Greater Dublin Drainage Project Addendum

**Environmental Impact Assessment Report Addendum:
Volume 3A Part B of 6**

**Appendix A8.1 - Responses to Marine Water Quality Questions at the
2019 Oral Hearing**

Response to Inspector's Questions

Fig 1(b): GDD model: Flood Tide

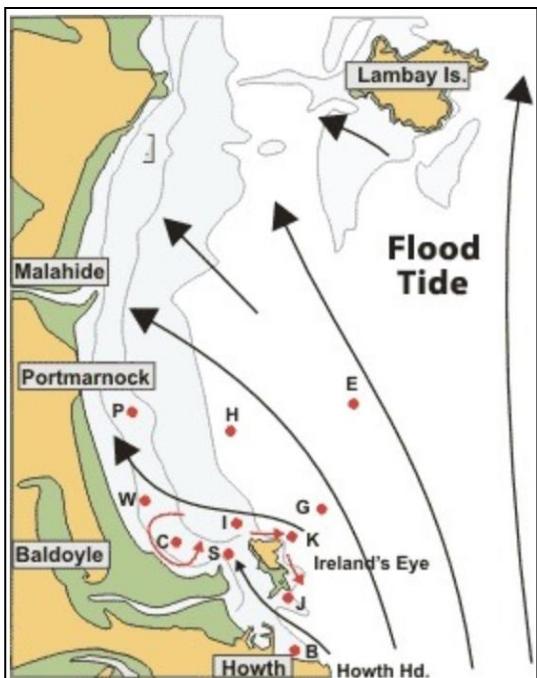
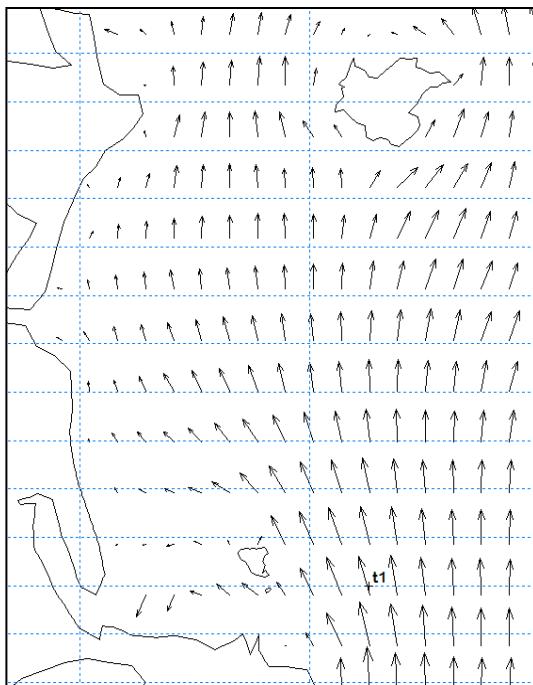
4. Returning to the present Proposed Project, with respect to the circulation patterns around Ireland's Eye as predicted by the model. Shown in the following figures is the model's representation of the flood and ebb tides compared directly with the maps from Howth Yacht Club. This material has previously been presented in the Response to An Bord Pleanala of Jan 2019.

6. Comparing Fig 1(a) with Fig 1(b) (from the Response to An Bord Pleanala of Jan 2019) for flood tide circulation patterns between Howth and Lambay Island it can be seen that; (i) both maps show the flooding tide to the north and east of Ireland's Eye stronger than the flooding tide between Ireland's Eye and the Bald Doyle Estuary as well as showing the same direction for the tidal currents; (ii) to the north of Ireland's Eye both maps show the flooding tide on a northwesterly heading with a notable westerly component towards Portmarnock; (iii) both maps show the flooding tide diverging to the east and west around Lambay Island;

Figure A1.15 – Dye Release, Spring 1

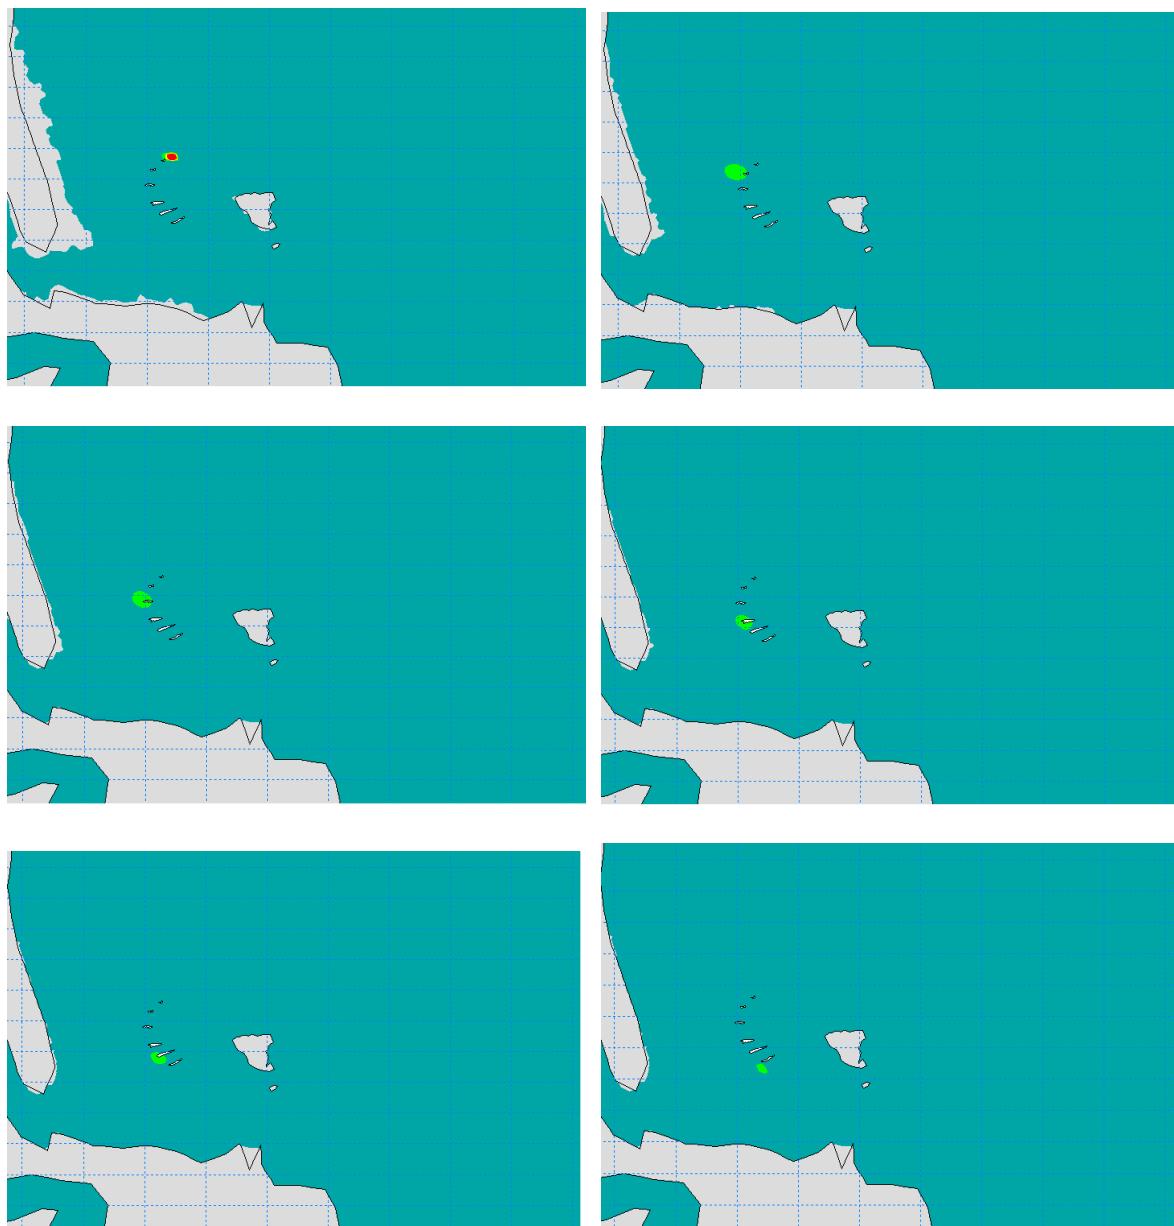
10. Moving on to the accuracy of the model in representing observed dispersion patterns in the region around Ireland's Eye; the solute transport (advection) model was calibrated against 2015 dye release surveys from locations around the area of interest, with 4 releases taking place on a spring tide and again on a neap (20th April 2015 and 9th June 2015 respectively. I submit a number of diagrams as presented in Appendix 8.1 of the EIAR.

11. These diagrams show that the model is capable of representing dispersion plumes in the area of interest around Ireland's Eye, both to the west and east of the island. The information published in the EIAR and Appendices shows that the model accurately represented the advection and dispersion of solute plumes throughout the area of interest.
 12. Specifically responding to Cllr Healy request that modelling results have been inadequately presented, I submit the following assessment at Velvet Strand, Claremont, Balscadden Beach and Irelands Eye (closest location to outfall) for the proposed discharge subject to UV treatment.
